Service Bulletin

Category S	Applicable Model/s 1995 Millenia	Subject RATTLING NOISE FROM FUEL TANK	Bulletin No. 011/95
			Issued 4/5/95
			Revised

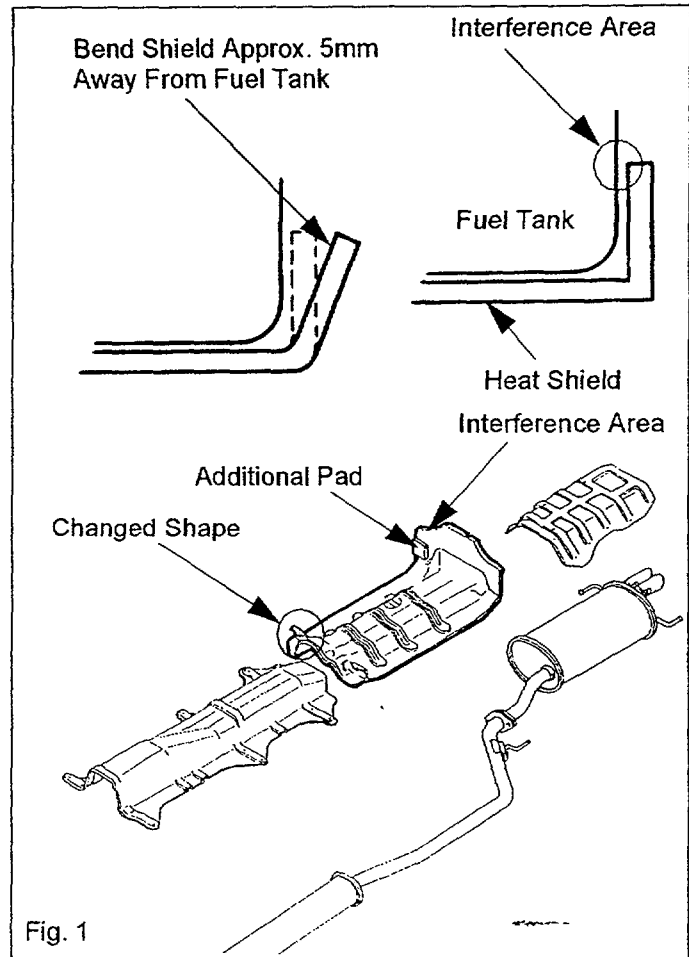
A rattling noise may be heard around the fuel tank area while traveling on rough roads. The noise is caused by interference between the fuel tank heat shield and the fuel tank.

To prevent this noise, the shape of the pad installed on the heat shield has been changed and another pad has been added.

1. Verify the complaint. If the noise is being produced from an area other than the fuel tank, refer to the workshop manual for troubleshooting and repair procedures.
If the noise is coming from the fuel tank area, proceed to step 2.
2. Lift the vehicle on a hoist.
3. Bend the heat shield away from the fuel tank approximately 5mm. Refer to Fig. 1
4. Test drive the vehicle to verify the repair.
